Addendum No.: 2

Bid#: 24-63-2

Project Name: Lacombe Trace Trails and Nature Park

SHEET L1.0

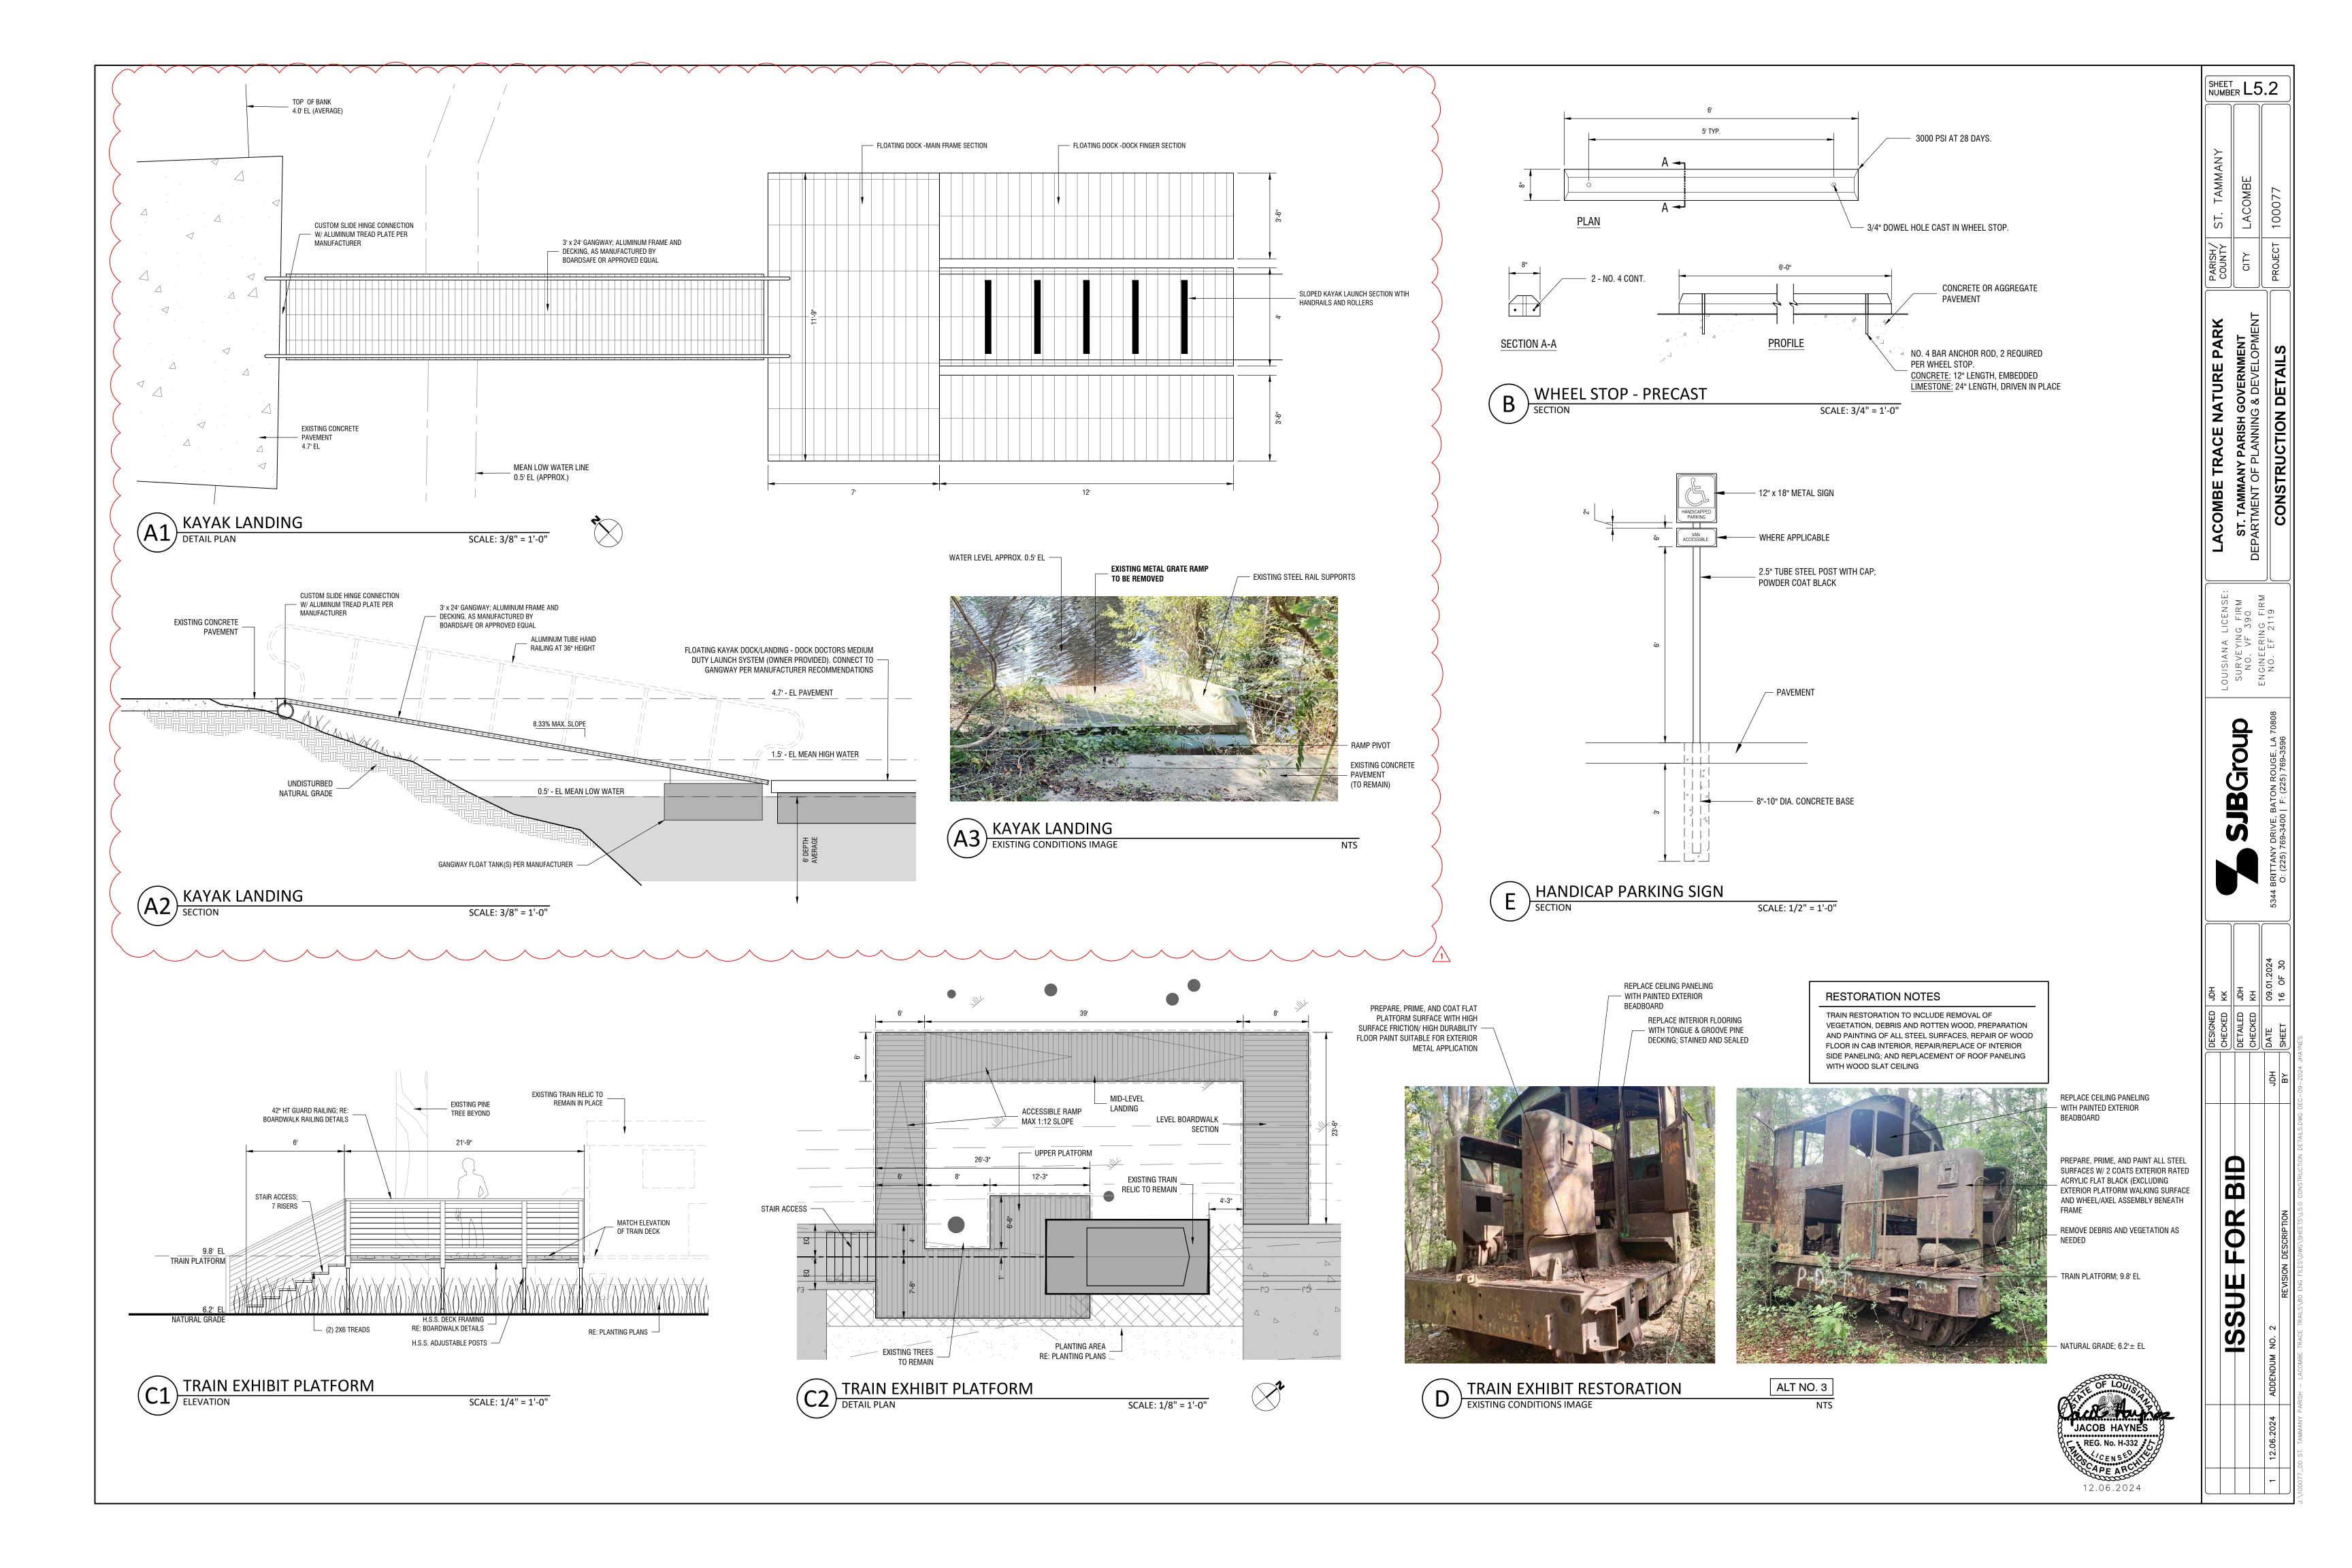
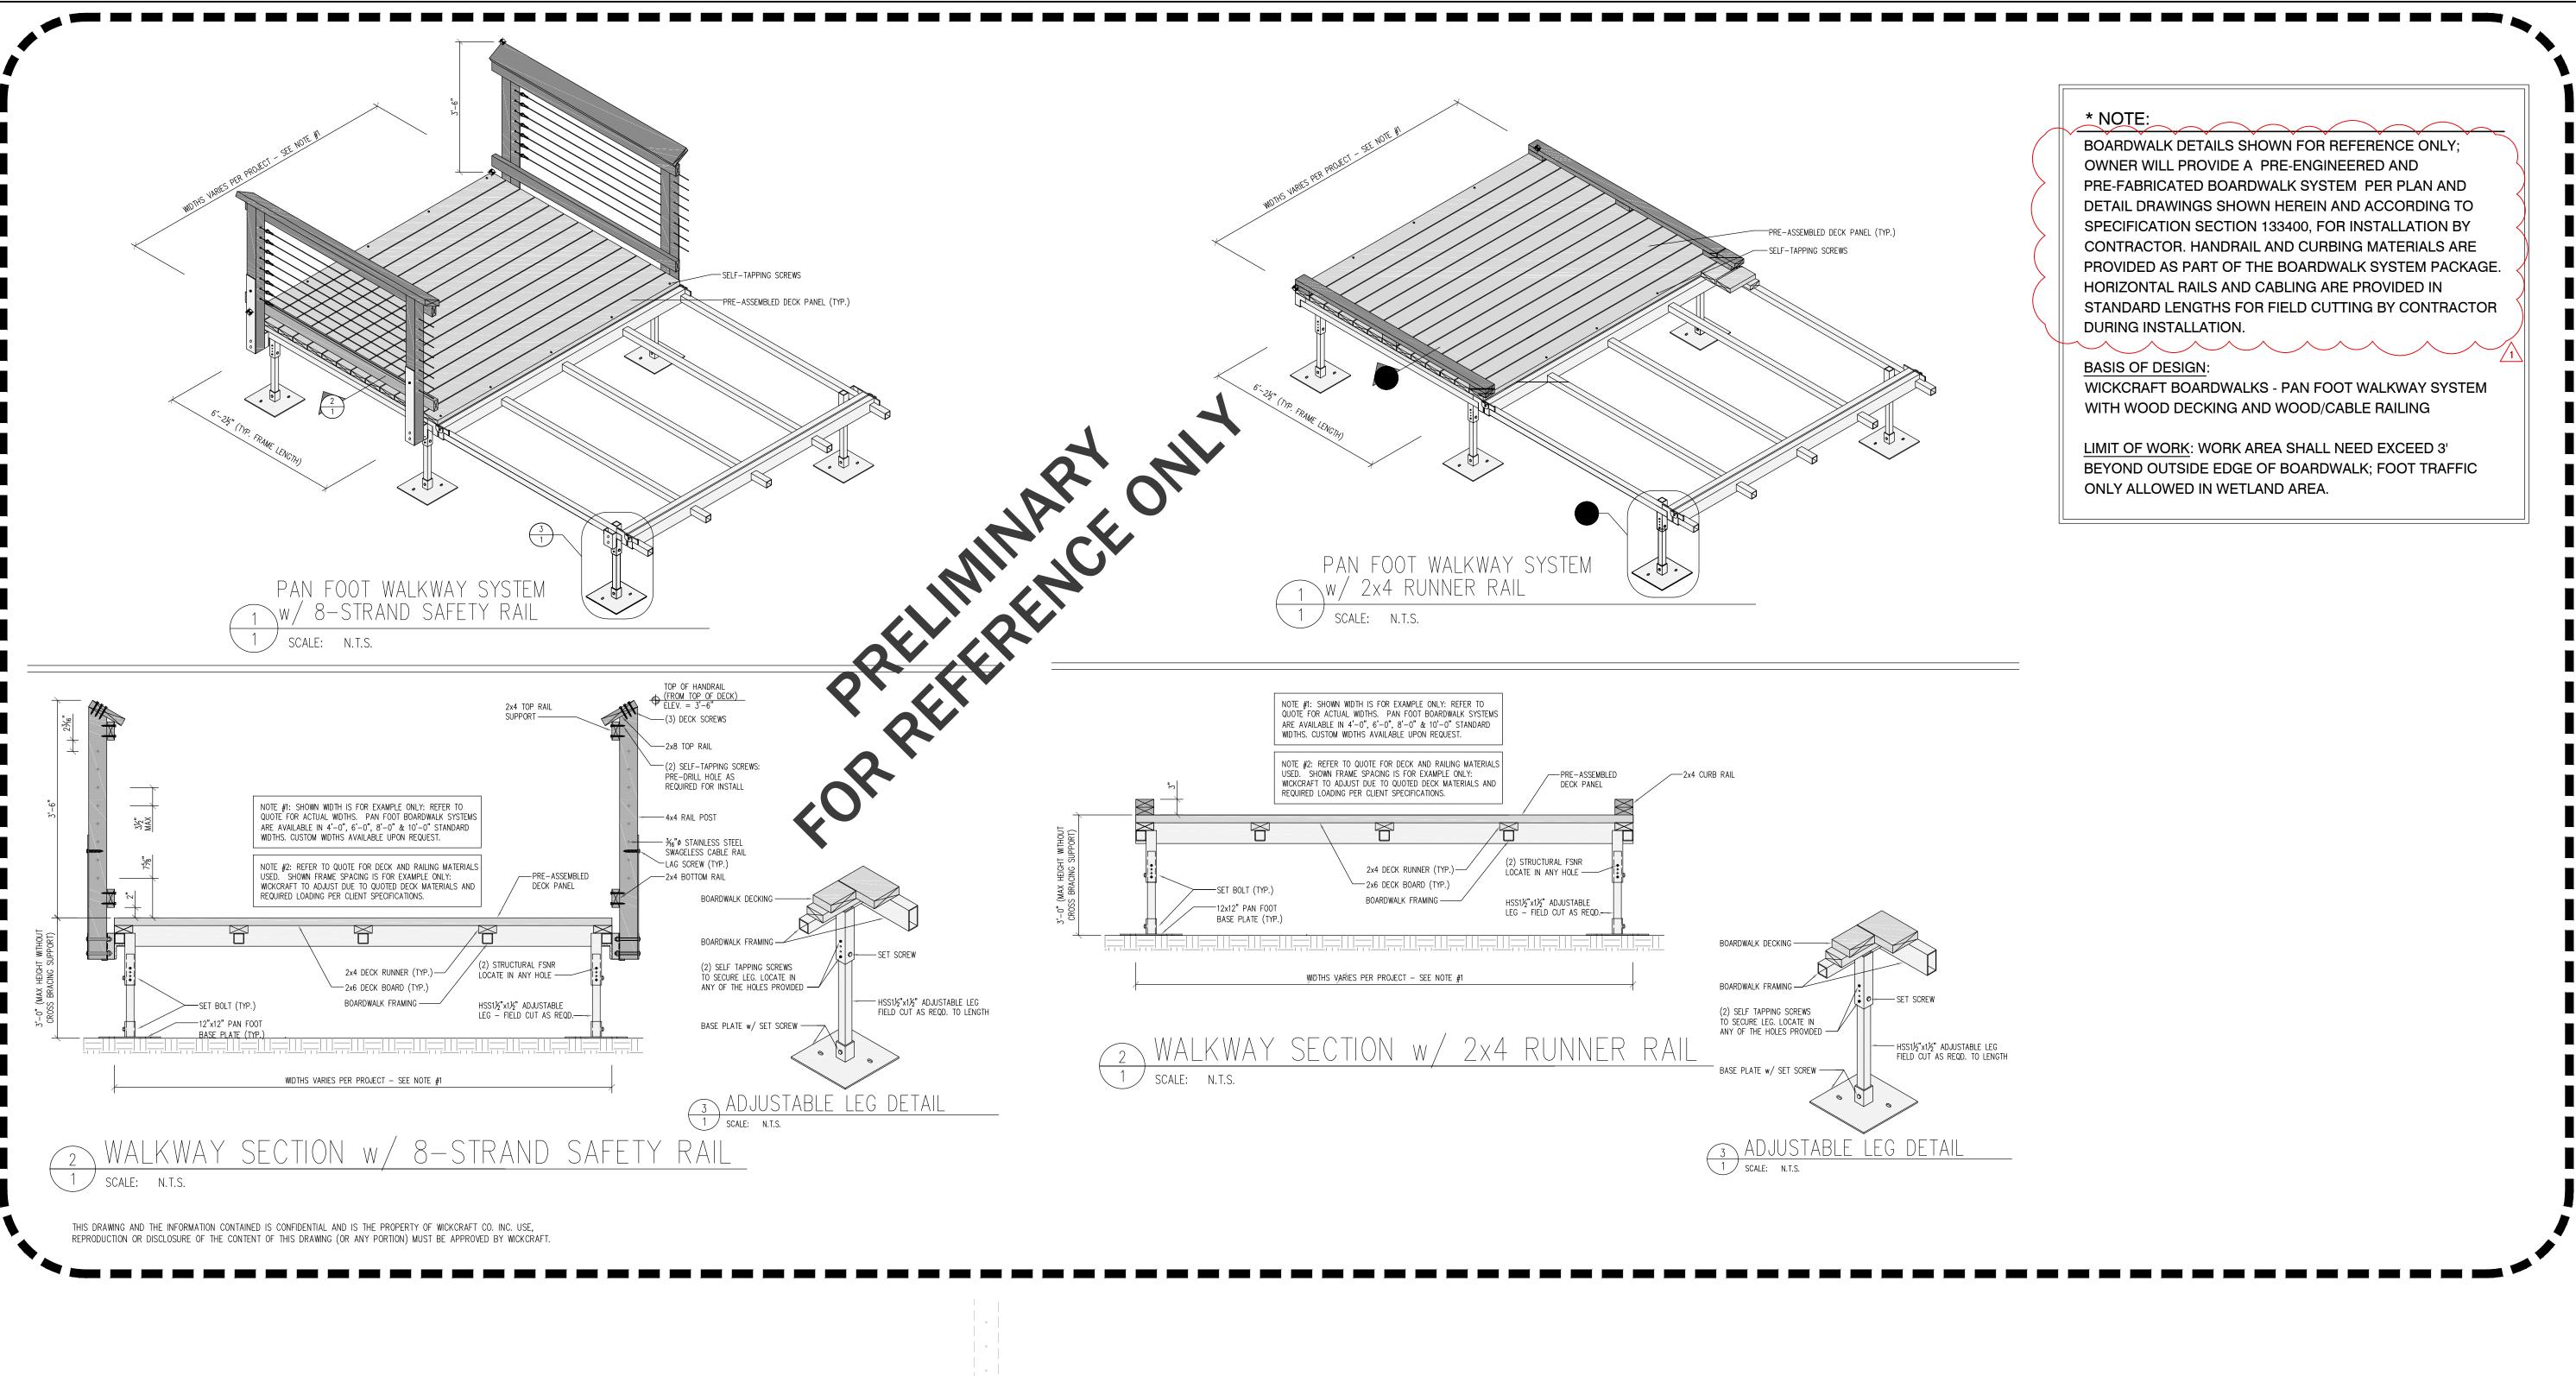
Sheet L1.0: Revise callout – EXISTING STEEL GRATE RAMP (TO BE REMOVED)
